Modifications to Universal Voltronics XRC-60-60N Power Supply to Add Analog Controls

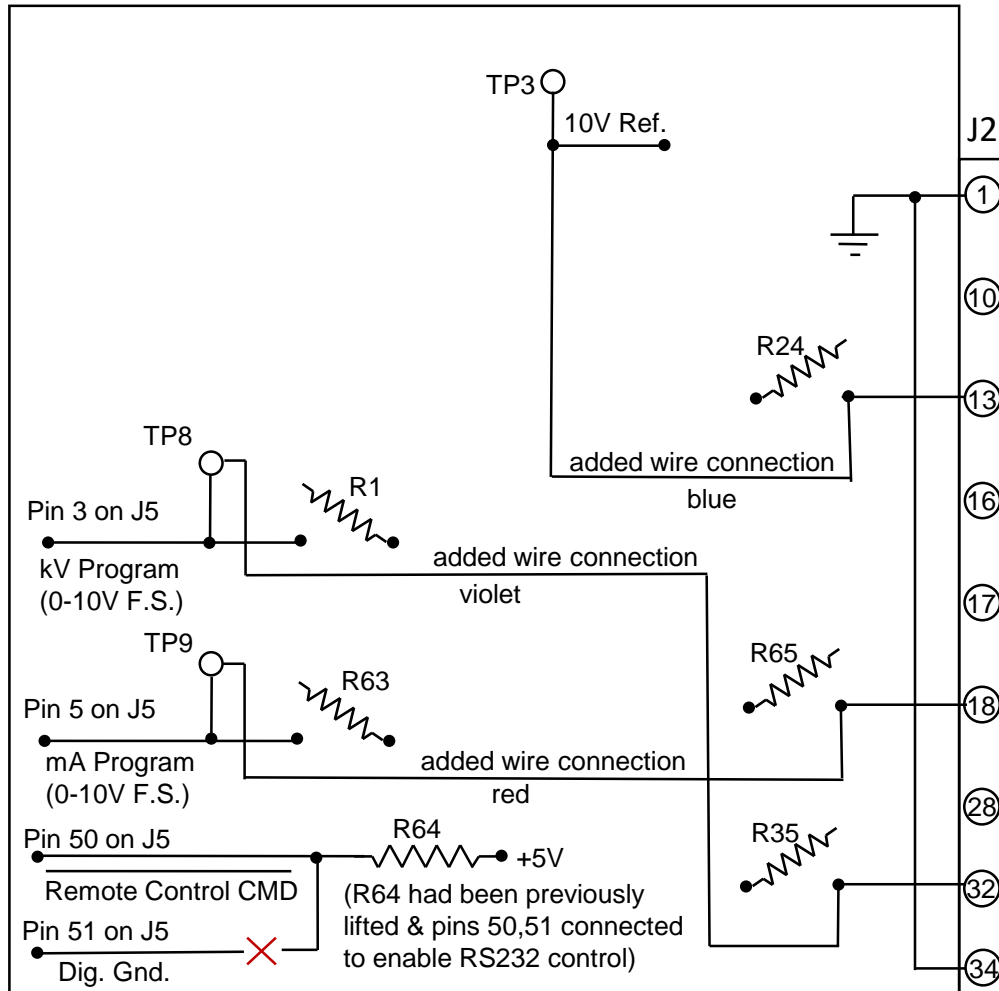
Note: This symbol indicates one end of resistor lifted from solder pad.

Note: Pins 13, 18, and 32 on J2 connector previously used as Safe Loop 1, 2, and 3 indicators were repurposed for analog control. Digital lines freed by disabling DAC's were not used because doing so required removal of resistor network chips. Lifting single resistors was easier and more readily reversible.
